Technical Service Bulletin

Subject: REAR ULTRASONIC SENSOR RUBBER SEAL(S) MISSING OR DAMAGED	Bulletin No.: 09-037/20
	Last Issued: 12/01/2020

APPLICABLE MODEL(S)/VINS

2020 CX-30 vehicles with parking sensor system with VINs lower than 3MVDM*****137194 (produced before Mar. 25, 2020)

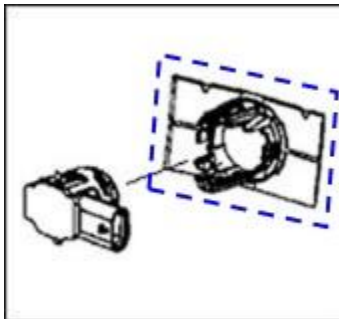
Rear ultrasonic sensor rubber seal is missing.

This concern is caused by the ultrasonic sensor sticking out too far from the rear bumper (as shown below). To eliminate this concern, the shape of No.1 and No. 2 ultrasonic sensor brackets have been modified.

2. Remove the No.1 and/or No.2 ultrasonic sensor bracket(s) according to MGSS online (REAR ULTRASONIC SENSOR REMOVAL/INSTALLATION).

7. Replace the No.1 and/or No.2 ultrasonic sensor bracket(s) with modified ones according to MGSS online (REAR ULTRASONIC SENSOR REMOVAL/INSTALLATION).
